**RE: Application for Permit Approval Amendment Modification
SEP-2016-12 (File #1582A)
164 Enterprise Drive, Monroe, CT
Project Number: 1604501**

PERMIT APPROVAL AMENDMENT MODIFICATION

Subject: Permit Approval Amendment Modification for
P&Z: SEP-2016-12-A1 (File #1582A)
164 Enterprise Drive

Sheet Title:	SITE LAYOUT PLAN PHASE 2	Sheet #:	2.12
--------------	--------------------------	----------	------

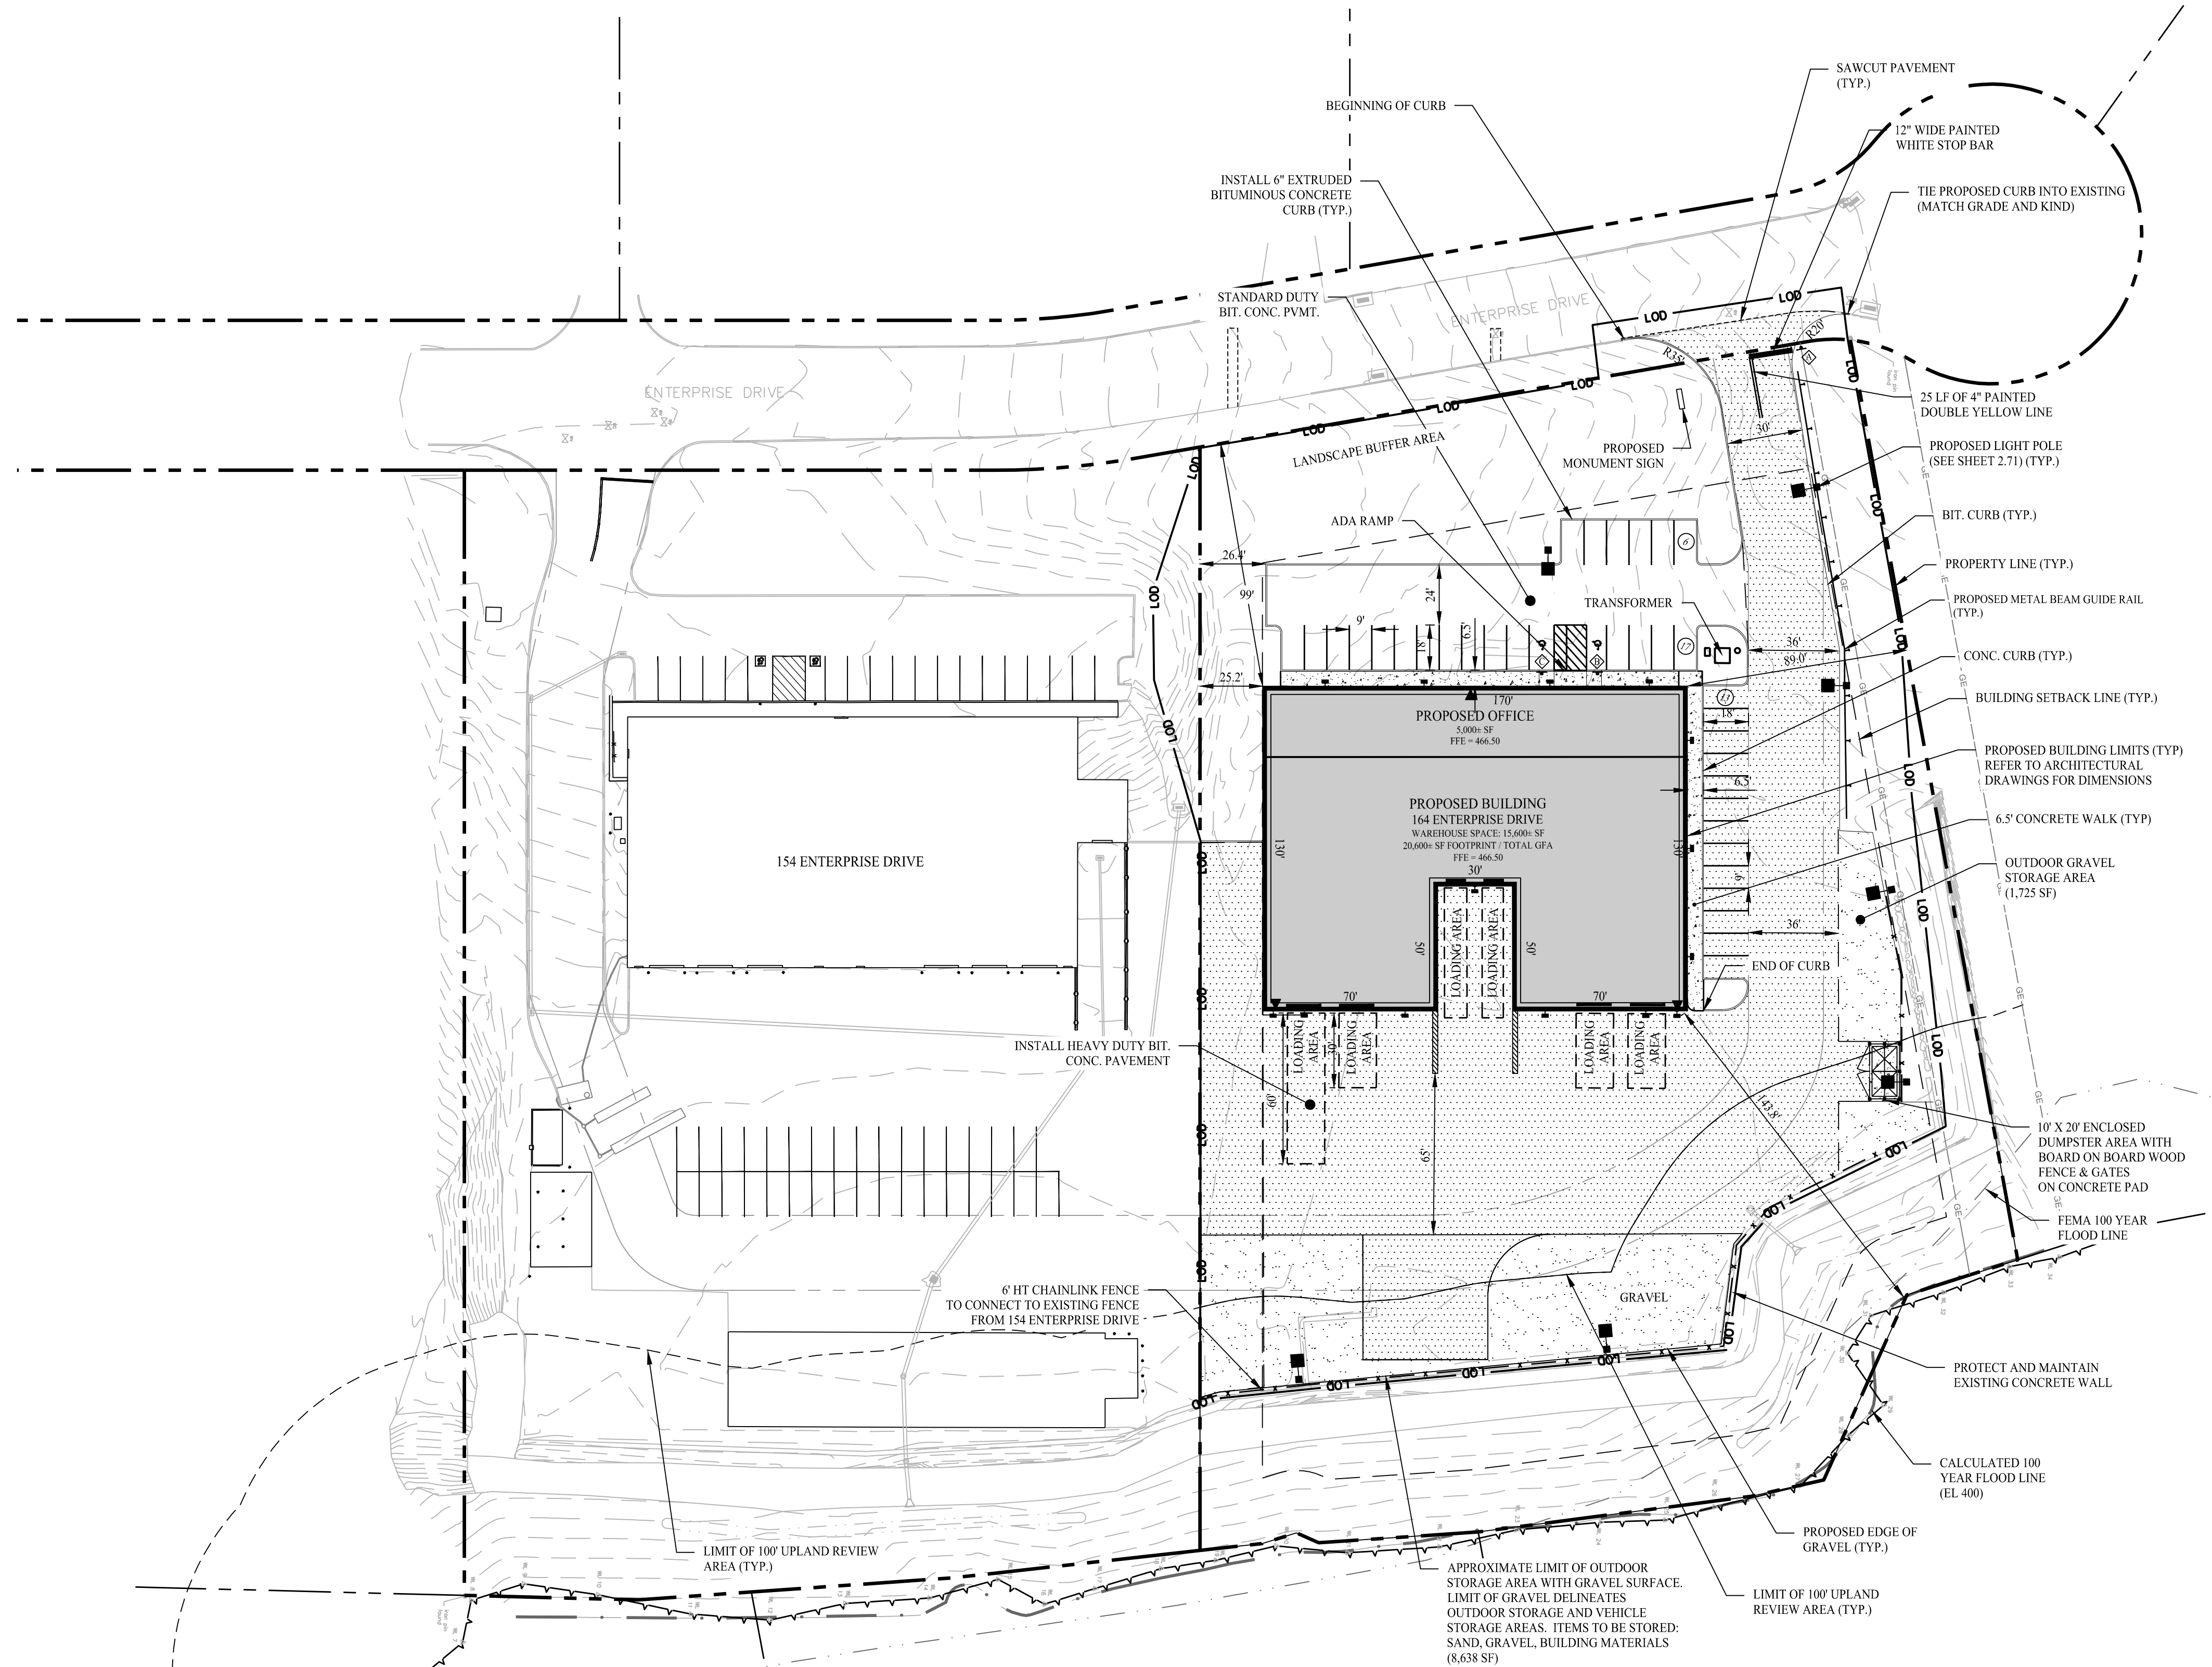
The Permit Approval Amendment Modification application proposes minor changes to the previously approved site layout plan. Below is a list of modifications to the previously approved plan that are depicted on the submitted Site Layout Plan:

- The plan has been revised to remove the previously approved fueling bay across from the north side of the building.
- The building footprint has been revised to accommodate a loading dock at the rear of the building.
- The gross floor area has increased by 200 square-feet from the previously approved 20,400 square-feet to the proposed 20,600 square-feet.
- The asphalt driveway was expanded into a previously approved gravel area at the rear of the site to accommodate truck maneuvering.
- The site was previously overparked by two (2) spaces for a total of 38 spaces. The proposed layout reduces the total parking to the required 36 spaces. The two spaces that have been eliminated at the northeast corner of the building to accommodate truck turning movements.

Sheet Title:	Sheet #:
GRADING AND DRAINAGE PLAN PHASE 2	2.22

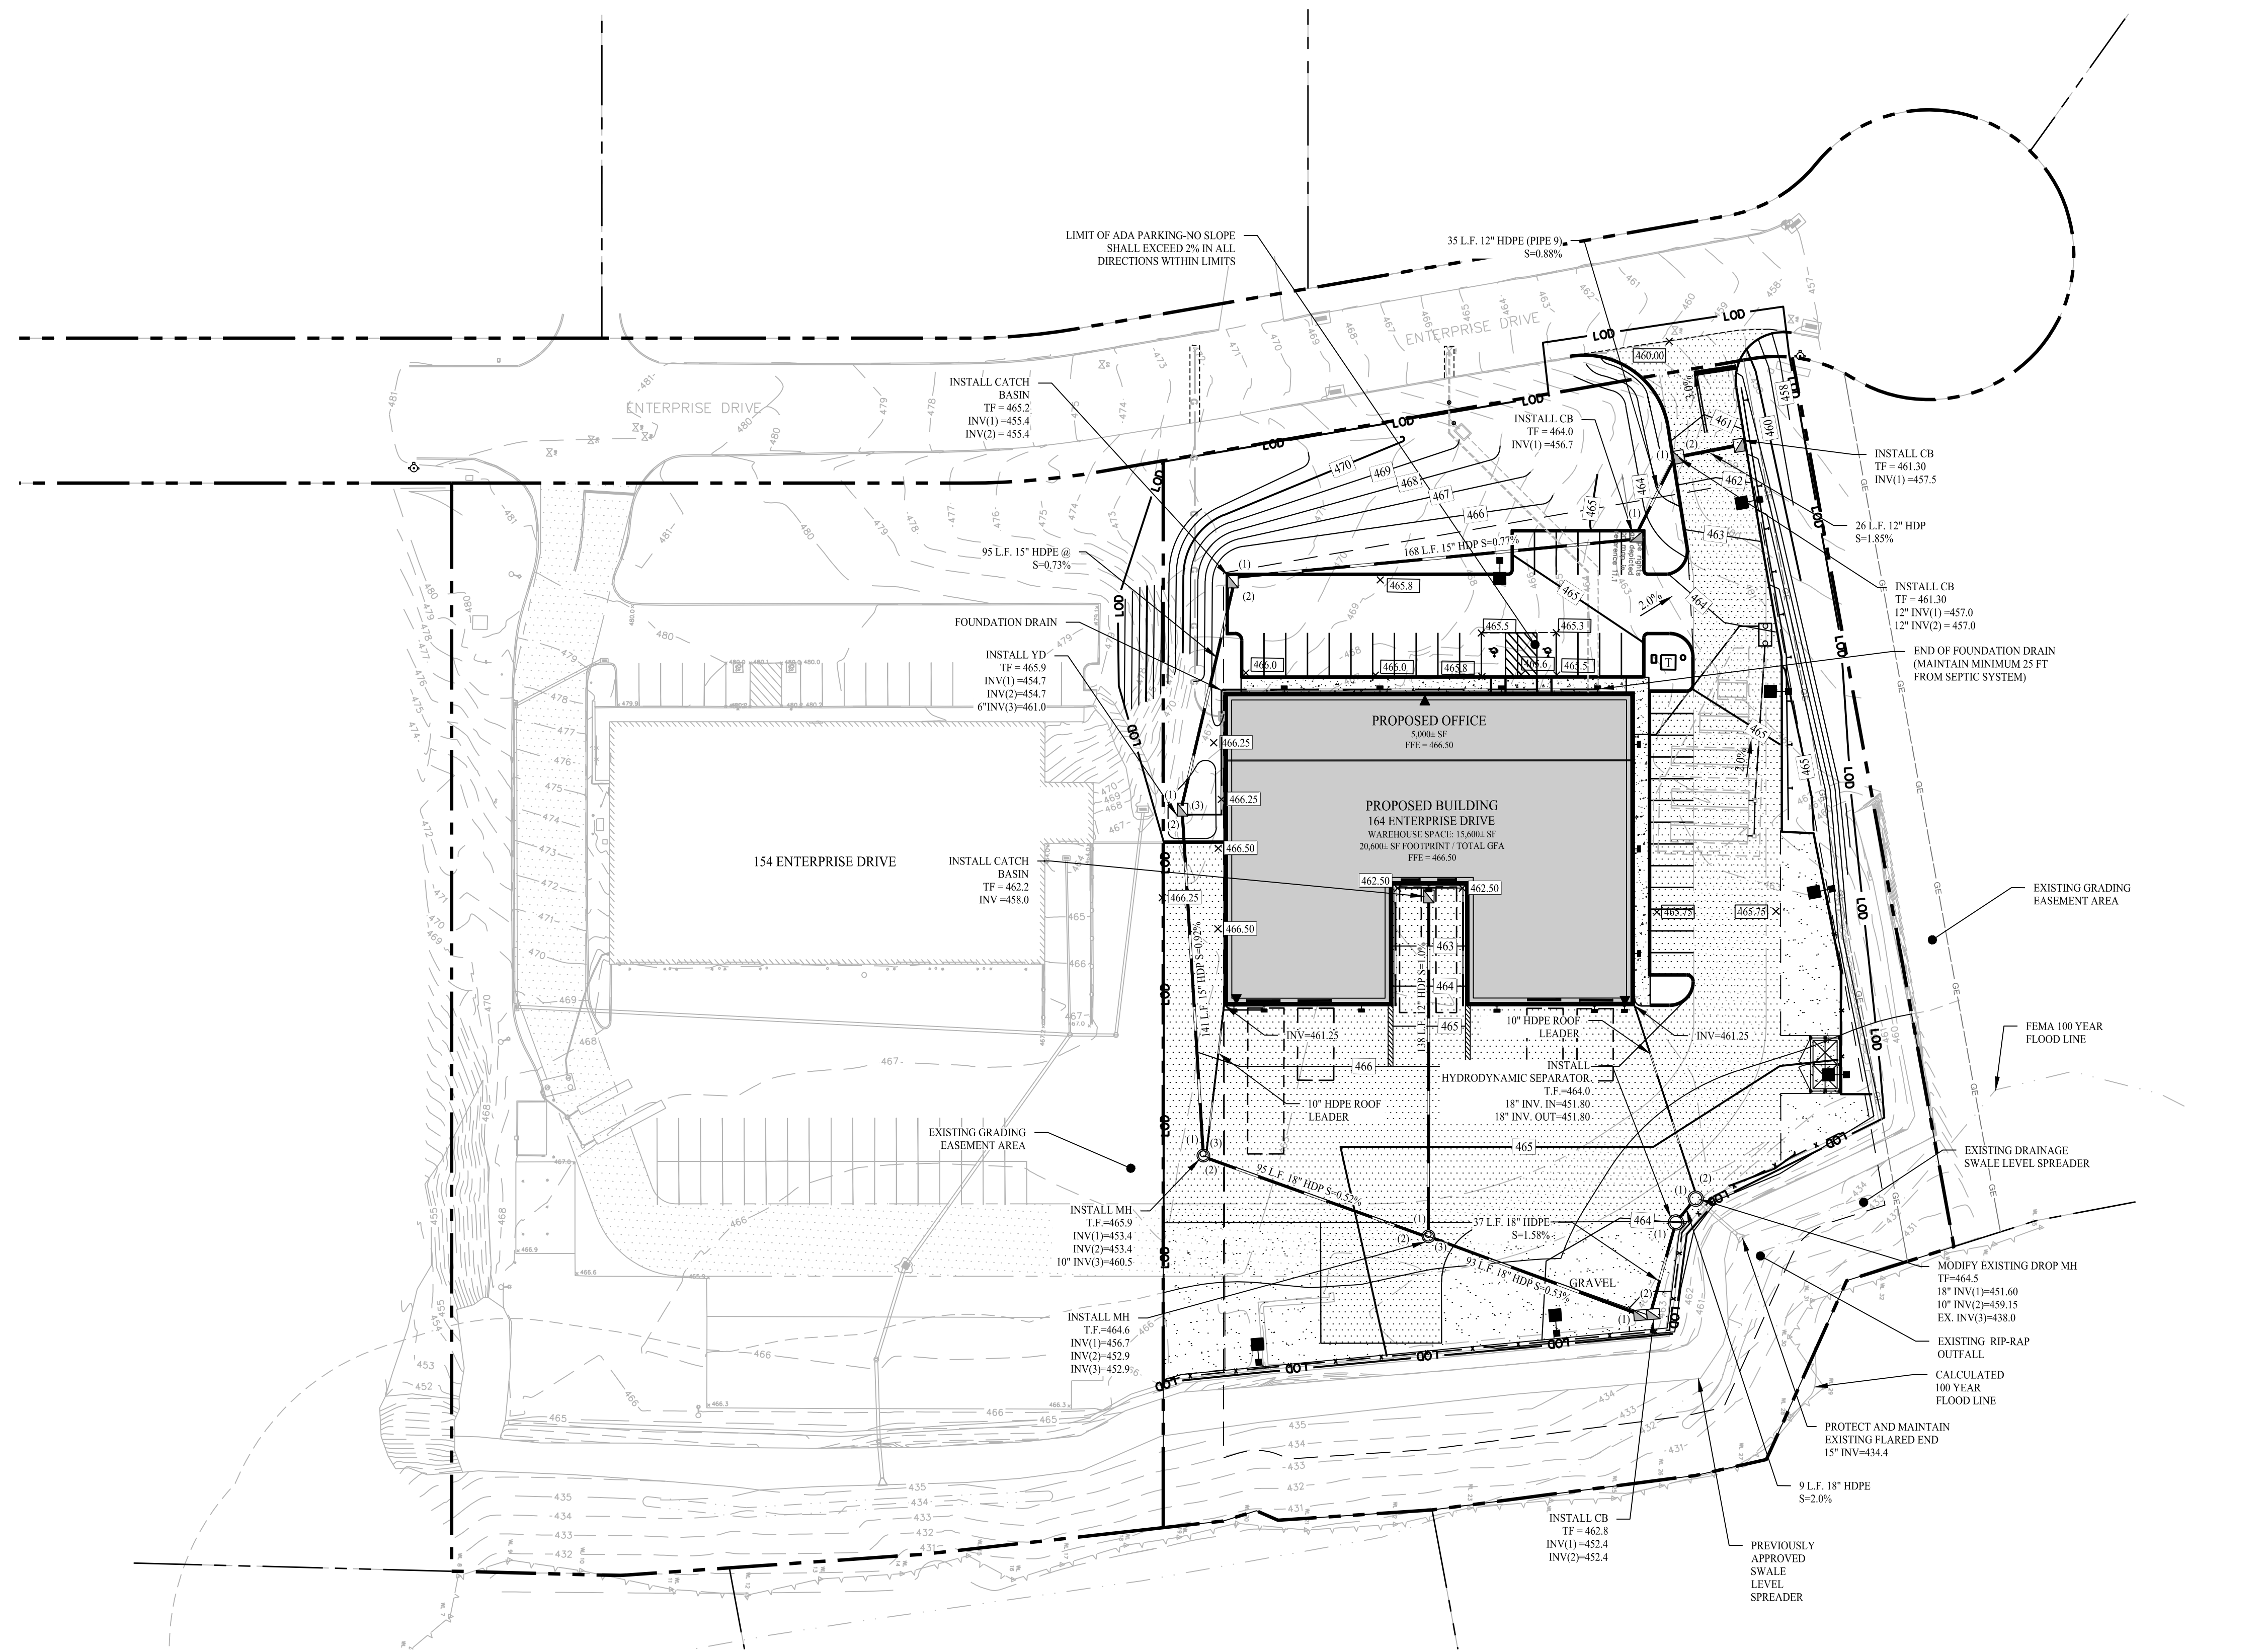
The Permit Approval Amendment Modification application includes The Grading and Drainage Plan, Sheet 2.22. Below is a list of modifications to the previously approved plan:

- Grading along the southwest corner of the property between the proposed parking lot, Enterprise Drive and the parking out of 154 Enterprise Drive has been modified to meet the as-built survey map's contours.

- Grading at the rear of the building has been adjusted to accommodate the deeper building and maintain a +/- 3% grade away from the building
- The grading contours and spot grades have been added to the truck well.

- Footing drains have been added to the front of the building and around the truck well. These drains are connected to the nearest catch basin. A call out has been added to indicate foundation drain to end prior to 25 feet from septic system.

- Roof leaders have been separated to the northeast and southeast corner of the building and connected to the collection system.
- The storm drainage collection system has been adjusted to accommodate the truck well and routing around the building. A separate drainage memorandum has been submitted along with this application to outline the changes in further details.
